# ADDENDUM #04 TO CONTRACT DOCUMENTS

**Project:** DTCC Terry Campus – Healthcare Center of Excellence Exterior Renovation  
Dover, Delaware

**Project Number:** BMG Project No. 2020179.00

**Subject:** **ADDENDUM #04**

**SKA-01**

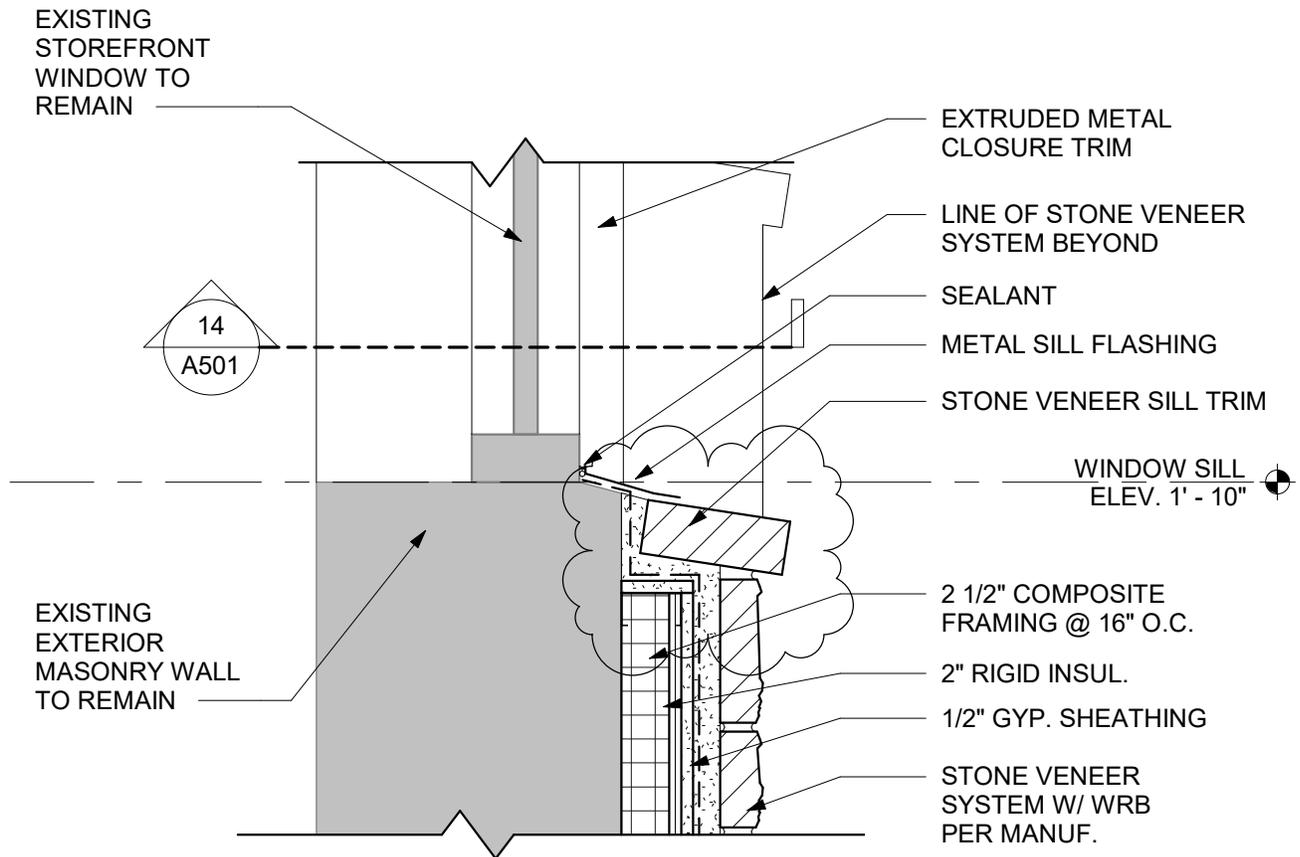
Item	Description
1	C901 – CONSTRUCTION DETAILS: A. Delete existing note reading ”8” CMU with reinforcement every course” in detail Dumpster Enclosure Detail, both Wall and Pad Section and Plan, Substitute the following “8” CMU w/ #4 vertical reinforcing bars at 8” O.C., embedded in concrete footing and ending within the top course bond beam, 9 gauge hot dipped galvanized ladder type horizontal reinforcement @ 16” O.C. above grade & 8” O.C. below grade, and 8” top course bond beam with (1) #5 bar continuous at the top. “
2	A501 – PLAN AND SECTION DETAILS: A. Delete Detail 6 in its entirety, Substitute revised Detail 6, SKA01, dated 01/18/23, attached. B. Delete Detail 7 in its entirety, Substitute revised Detail 7, SKA02, dated 01/18/23, attached
